February 26, 2016

03188 Version 5

Safety Recall: Piston Pin Snap Ring InspectionSupersedes 16-017, dated February 24, 2016, to revise the information highlighted in **yellow**.**AFFECTED VEHICLES**

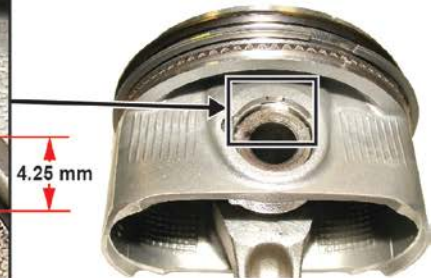
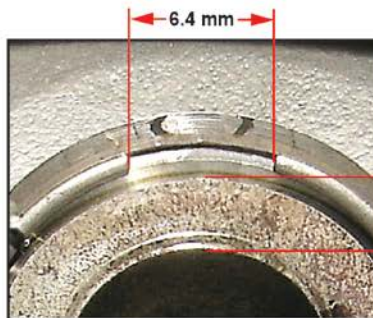
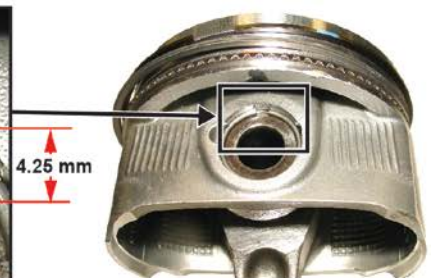
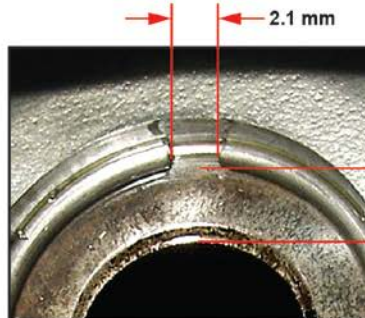
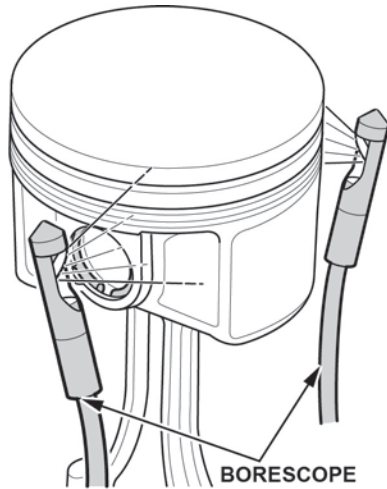
Under INSPECTION PROCEDURE, a note and picture was added under step 16, and a note was added under step 19.

16. Using the Snap-on BK5600 with the 90-degree tip installed, rotate the engine so the No.1 cylinder is at TDC. Carefully insert the tip of the borescope and inspect cylinders No.1 and No.4. Then, rotate the engine so the No.2 cylinder is at TDC and repeat the process with cylinders No.2 and No.3.

NOTE: You may notice a black mark on the snap ring and piston. This is a factory check mark and could be mistaken for the snap ring gap.

17. Rotate the probe to confirm that the snap ring is fully engaged in the piston pin groove. A properly seated snap ring will have a 6 mm gap at the ends of the snap ring, as shown above. A misset snap ring will have a much smaller gap, around 2 mm.
18. Take a photo of each snap ring. Focus on getting a clear picture of each snap ring gap. You will need to take a picture of each side of all four pistons for a total of eight pictures.

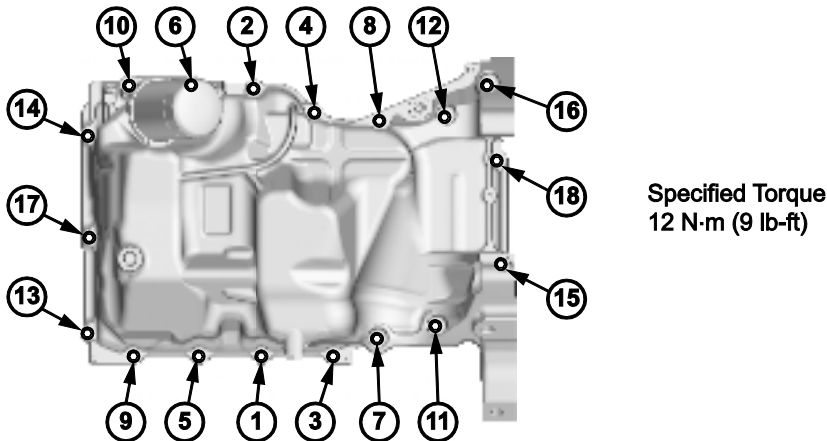
- If the snap ring is misset, take a clear picture of the misset snap ring and contact Tech Line to assist you with obtaining replacement piston assemblies.
- If a snap ring is missing and the engine cylinder wall does not have any damage, take a clear picture of the piston pin with the missing snap ring and contact Tech Line. They will assist you with obtaining the replacement piston assemblies.
- If the snap ring is missing and the engine has cylinder wall damage, order a replacement short block.

NOTE: When installing the oil pan, apply a 2.5 mm bead of Honda Bond HT to the mounting surface. Install the oil pan within 5 minutes and torque the bolts in three steps in the sequence shown below. In this specific application no cure time is required.
